STAFF REPORT
KETCHUM PLANNING AND ZONING COMMISSION
REGULAR MEETING OF SEPTEMBER 23, 2025

PROJECT: Sawtooth Serenade

FILE NUMBER: P24-027

APPLICATION: Final Design Review

Sheet Title:
GLAZING REFLECTIVITY

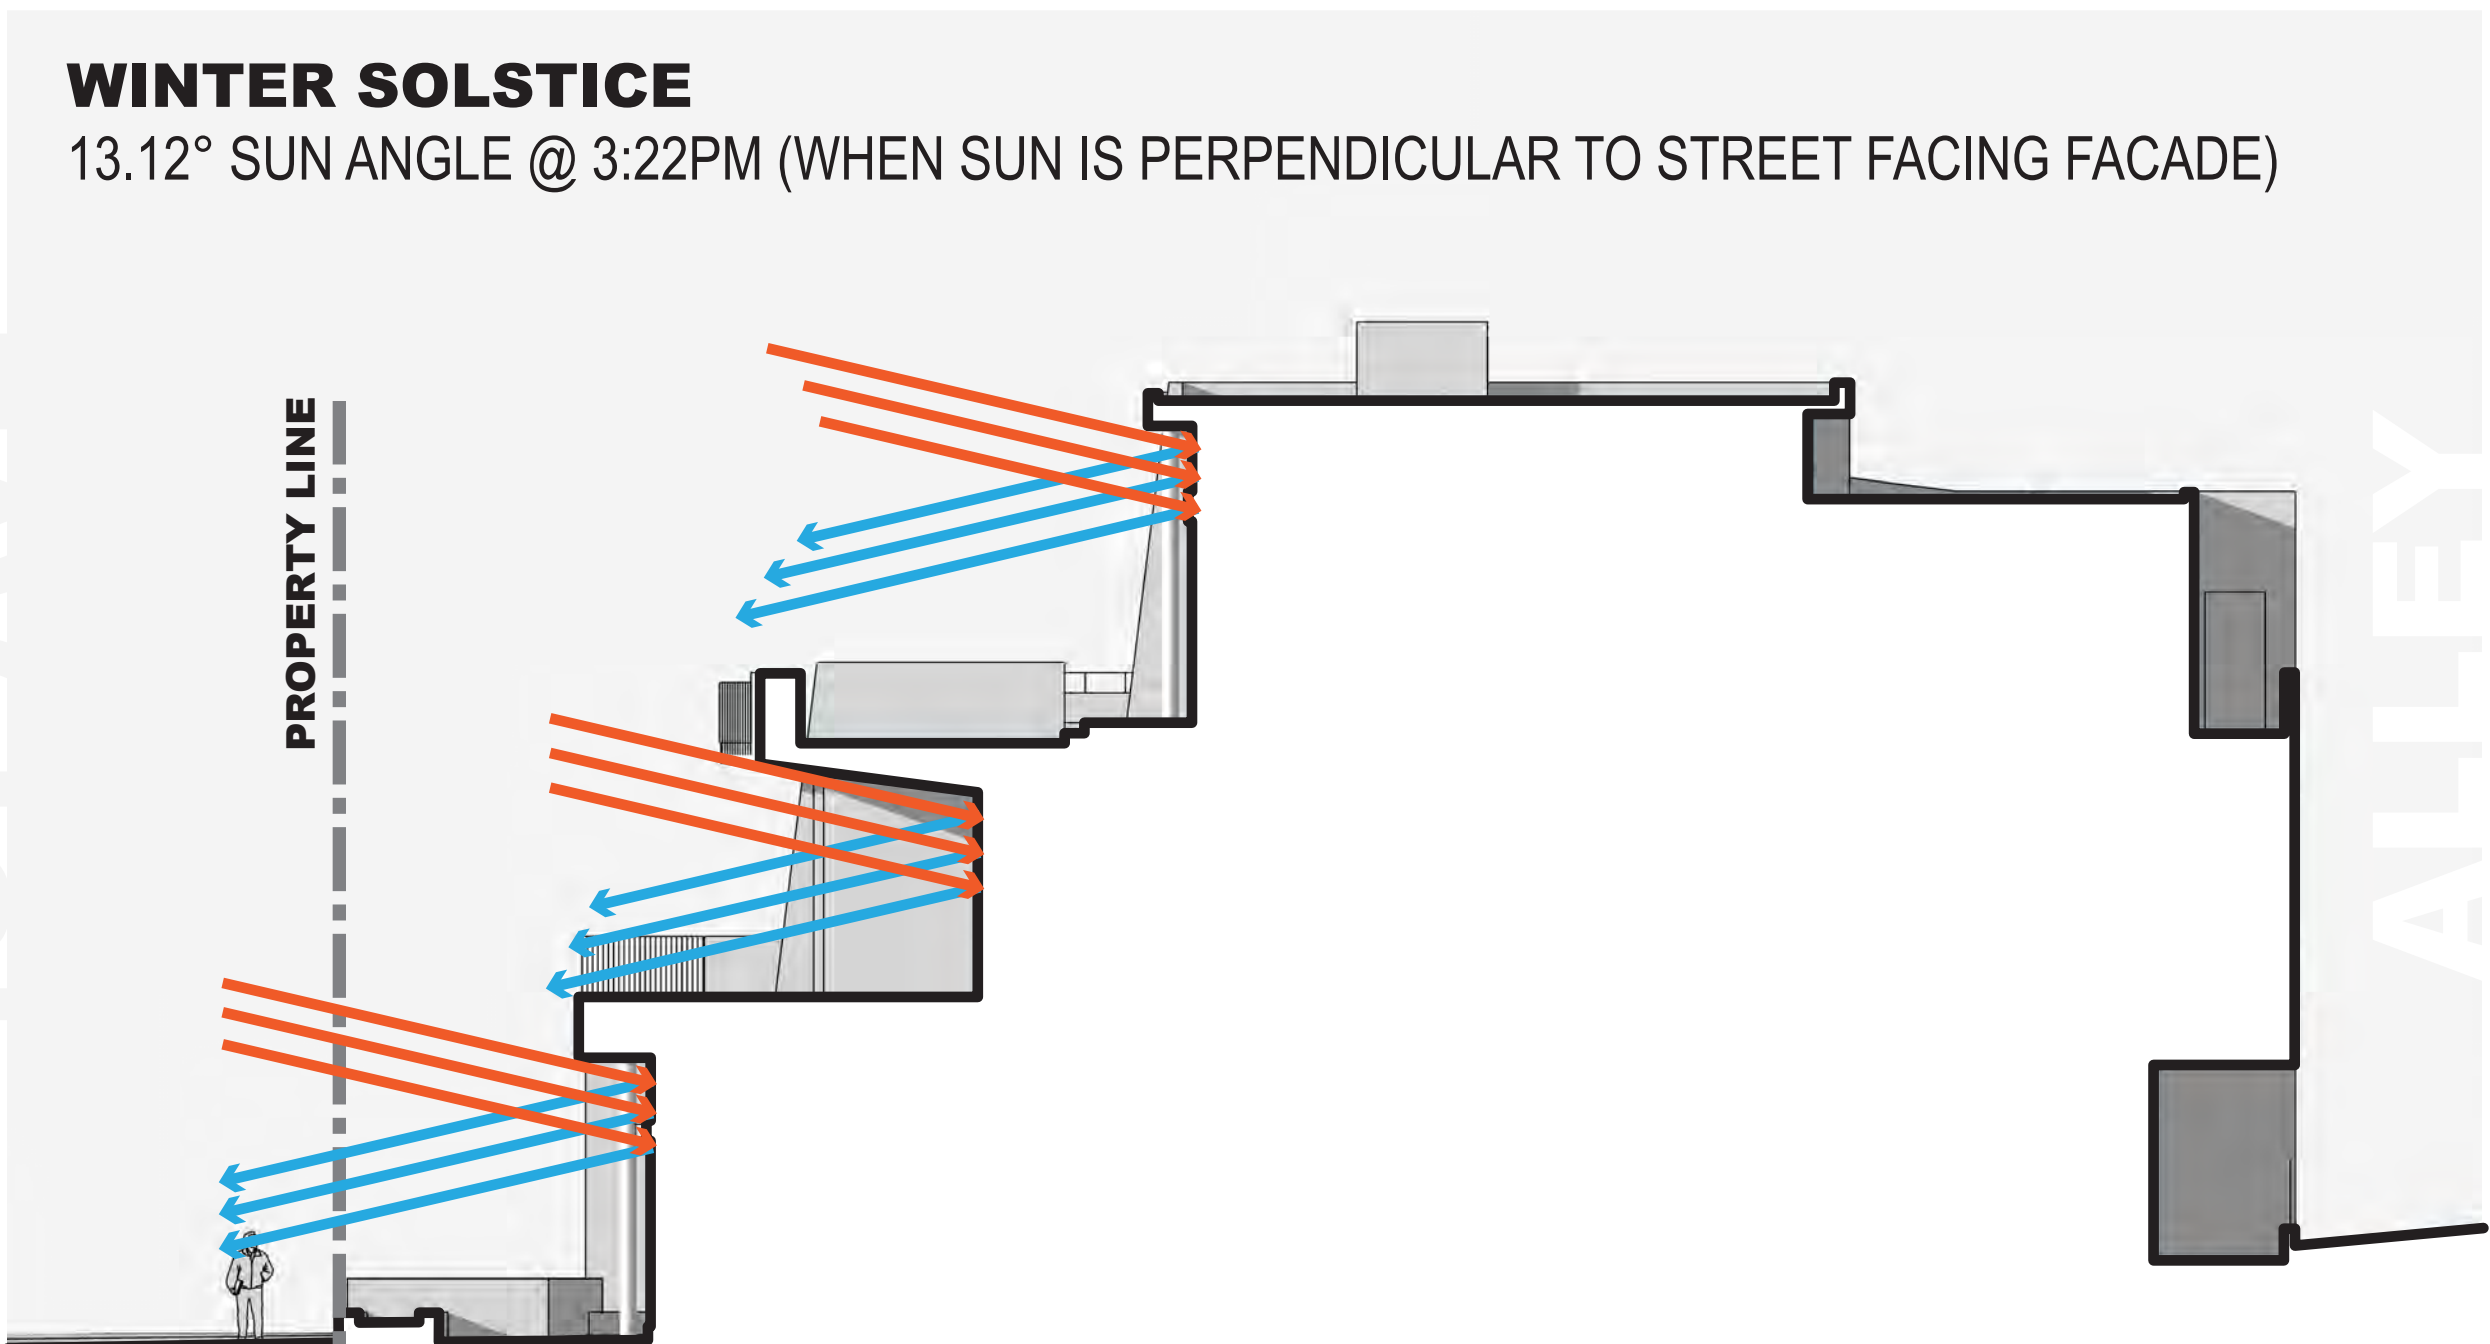
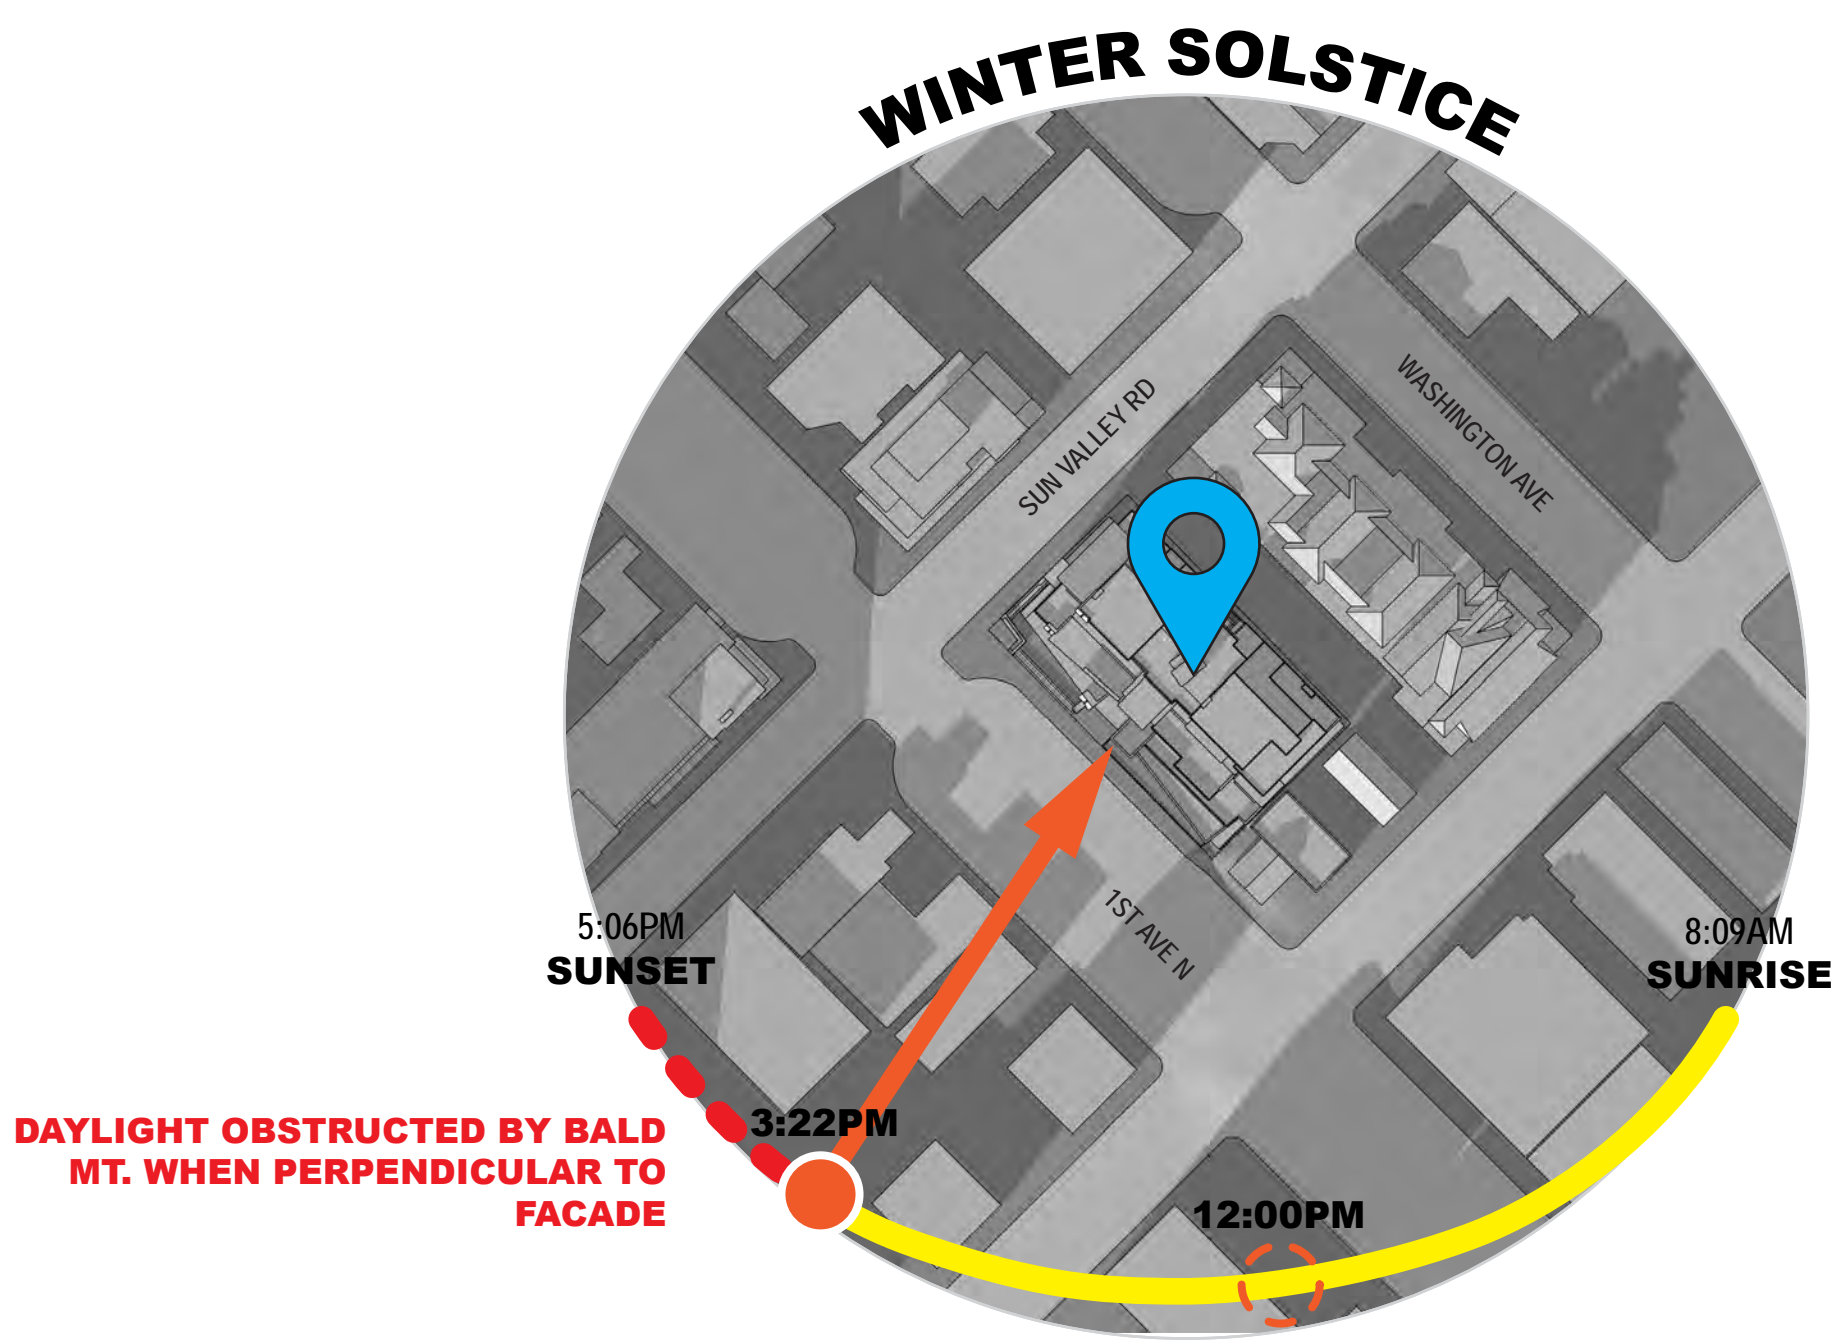
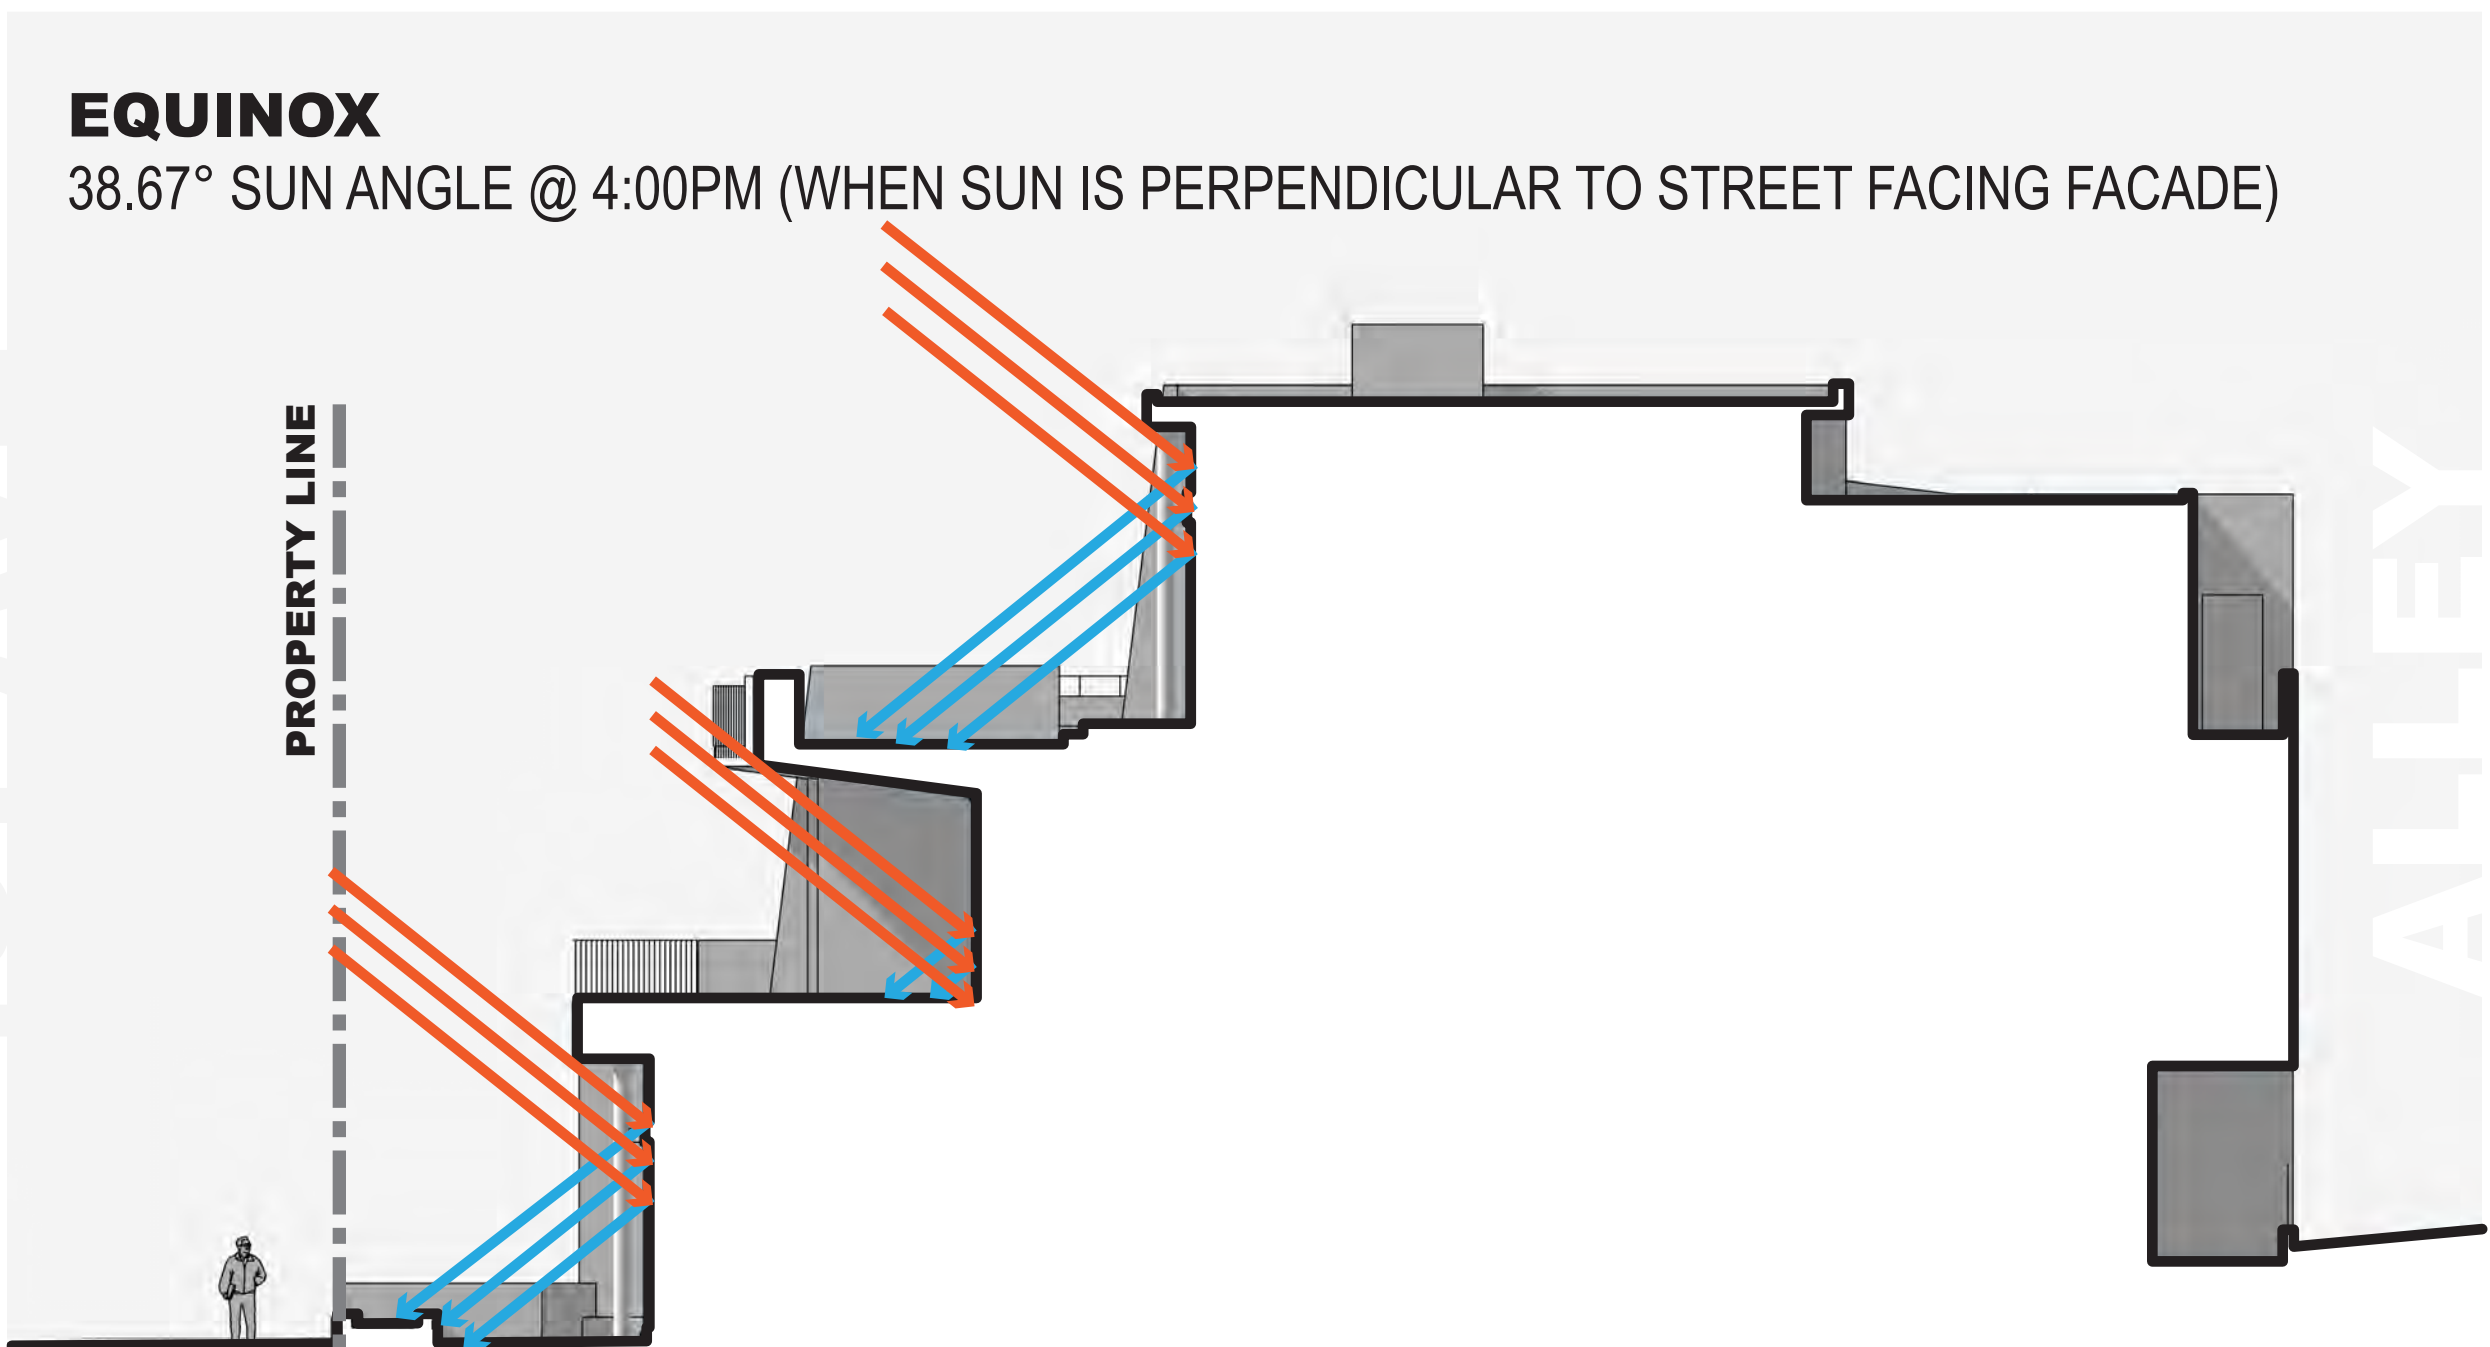
- In one of our coordination meetings with Morgan Landers, she commented that the amount of glazing on 1st Avenue could mean that, at certain times of the day, the sunlight reflecting off the building could be dazzling to people on the street. Because of the cascading nature of the design, the forms of the Lynches’ home and the recessed windows and sunshades of the Berniers’ home, very little reflected sunlight will reach street level. We have done sun studies, and our submittal Sheet A0.14 provides reflected light diagrams showing that only late in the afternoon, in the darkest part of winter, and just before the sun goes behind Baldy, will sunlight reflecting off the building windows reach the public right of way.

During winter months a small fraction of clerestory fenestrations will reflect light into the public right-of-way.

The following diagrams illustrate fenestration reflections at peak times of day. When the sun is perpendicular to the 1st Ave N facade.
